PRODUCT / PROCESS CHANGE INFORMATION

1.1 Company		STMicroelectronics International N.V
1.2 PCI No.		CRP/22/12731
1.3 Title of PCI		CHANGE OF SUPPLIER FOR 3CP21710 (CARRIER TAPE Wi 12mm QFN/LGA 5x5x0.55)
1.4 Product Category		Refer to impacted product list
1.5 Issue date		2022-04-08

PCI - CHANGE OF SUPPLIER FOR 3CP21710 (CARRIER TAPE Wi 12mm QFN/LGA 5x5x0.55)

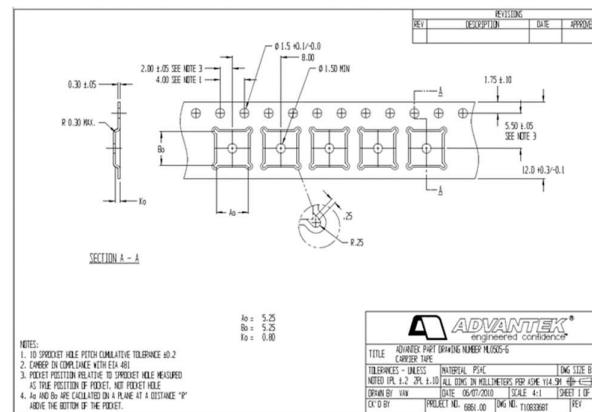
Change of supplier for ST material code reference: 3CP21710 (CARRIER TAPE Wi 12mm QFN/LGA 5x5x0.55) from PEAK to ADVANTEK which affected ST CALAMBA.

CURRENT: PEAK

NEW: ADVANTEK

Visual Inspection Report

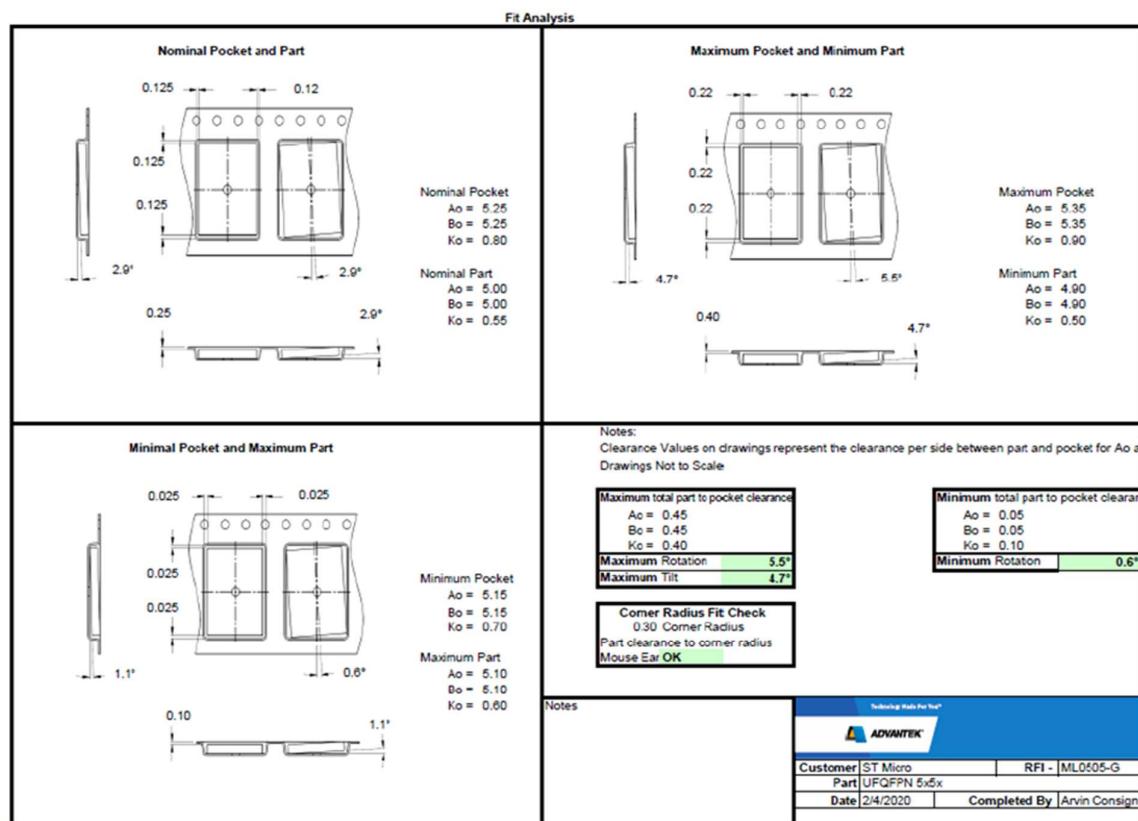
Visual inspection	Results
Does not contain stain or foreign material	Passed
No Damage	Passed
No Burr	Passed
Orientation	Passed
The component does not protrude above the top surface of the carrier tape	Passed
The component can be removed from the cavity in a vertical direction without mechanical restriction, after the top cover tape has been removed.	Passed
Lateral movement of the component is restricted to 1.0mm maximum	Passed
